INSTITUT LUXEMBOURGEOIS DE RÉGULATION

**Projet de l'élaboration d'un modèle de coûts fixe
NGA-NGN**

Réponse aux contributions soumises à la demande d'avis menée
du 31 octobre 2013 au 3 janvier 2014

Response to stakeholder comments

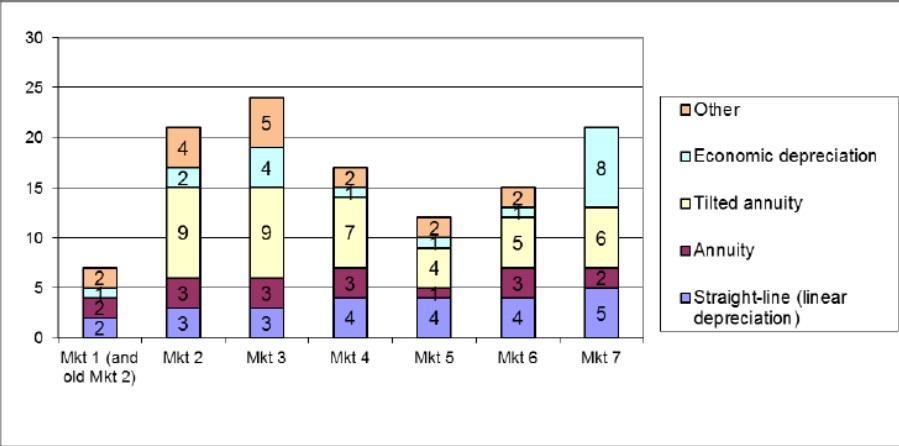
Section	Stakeholder comment	ILR response
	<p>The tilted annuity formula should be adjusted for FTTH to reflect that demand is growing so that the cost recovery better reflects economic depreciation.</p>	<p>The tilted annuity formula is a well-understood and widely adopted approach to calculating depreciation charges. In principle, the adjustment proposed allows for closer approximation of true economic depreciation since it allows for the consideration of changing demand. However, in practice, such an approach would require detailed forecasts of demand over the full lifetime of the assets modelled. In some cases (e.g. duct) such asset lifetimes are very long - 40 years. It is therefore difficult in practice to estimate an adjustment for changing demand in a robust way.</p> <p>Moreover, the tilted annuity method is a best practice in other European jurisdictions (cf. Figure 3 of the BEREC Report on Regulatory Accounting in Practice 2013).</p>
